Subject: Supplement (3rd) to the Roof-Control Plan, Upper Big Branch Mine-South, I.D. No. 46-08436, Performance Coal Company, Montcoal, Raleigh County, West Virginia, Permit No. 4-RC-11-94-12307-10, approved January 21, 2004

Drawing No. 19A

Full Pillar Plan (MRS)

34A Supplemental Page -

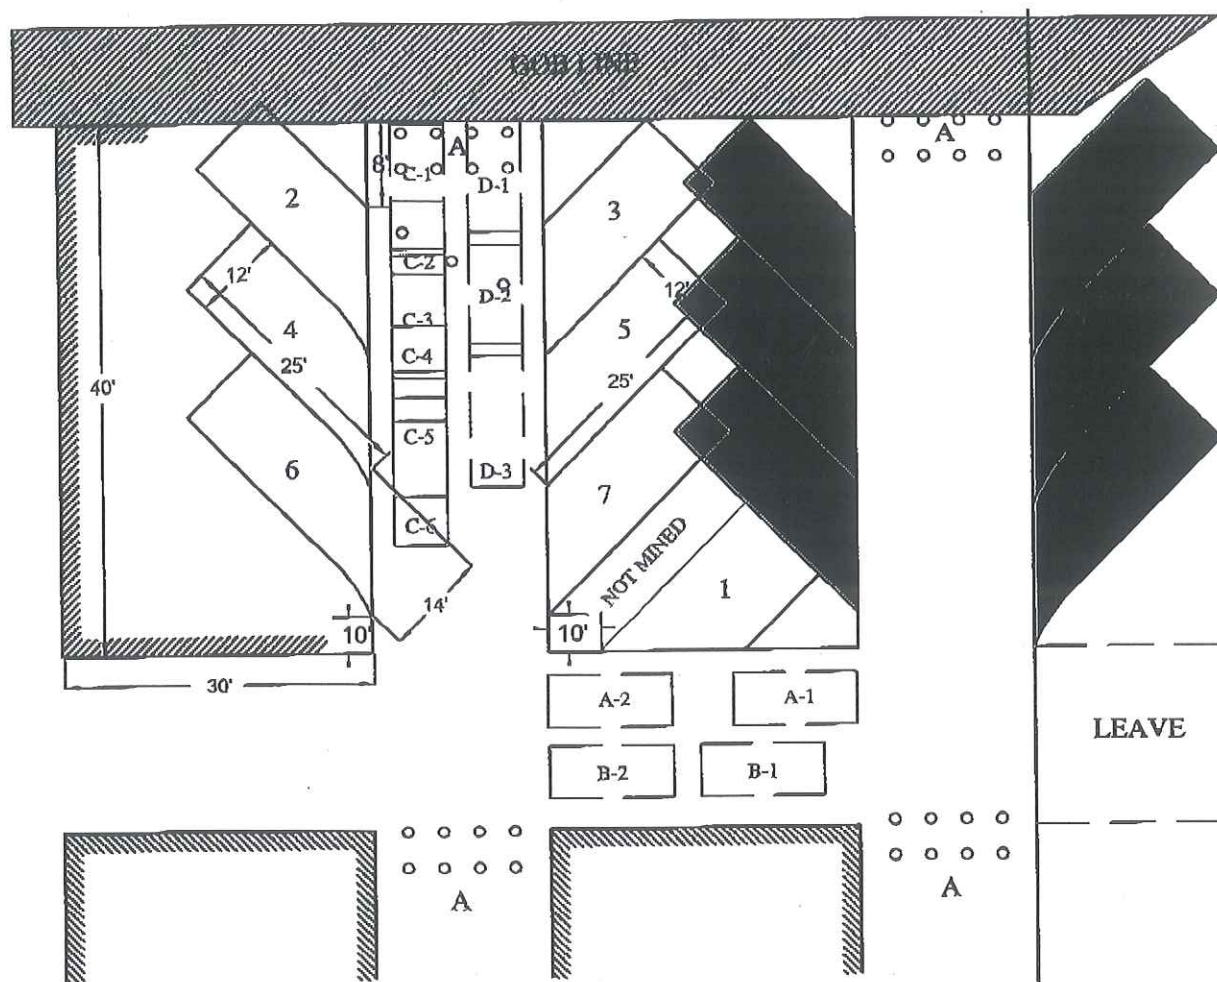
When mining the cut out of the crosscut as the first lift, safety precaution #34 on page 8 will be complied with. When this cut is not the first cut, safety precaution #34 does not apply.

Performance Coal Company, Upper Big Branch Mine-South (ID 46-08436), is submitting the attached Drawing 19A (full pillar plan with Mobile Roof Supports) as an alternate cut sequence plan. We would like the option to take cut #7 as the first cut. This plan will be added to the roof control plan as page 34A. Also, an additional safety precaution was added to the roof control plan as precaution #34 on page 8. This precaution will be complied with when the cut sequence is done as shown on Drawing 19A. When the cut sequence is that shown on Drawing 19, then safety precaution #34 does not apply.

1. Breaker Posts (A) are to be installed after mining is completed inby.
2. MRS Units will be set at locations (A-1) and (B-1), and also at (C-1) and (D-1) prior to mining Cut #1.
3. MRS Units will be set at locations (D-1) and (C-1), and also at A-2 and B-2 prior to mining Cut #2.
4. MRS Units will be set at locations (C-2) and (D-1) prior to mining Cut #3.
5. MRS Units will be set at locations (C-3) and (D-2) prior to mining Cut #4.
6. MRS Units will be set at locations (C-4) and (D-2) prior to mining Cut #5.
7. MRS Units will be set at locations (C-5) and (D-3) prior to mining Cut #6.
8. MRS Units will be set at locations (C-6) and (D-3) prior to mining Cut #7.
9. (8) Breaker Posts will be set at location (A) immediately after completion of mining in block.

When mining twins lifts from the same opening, cut depths will not exceed half the block width.
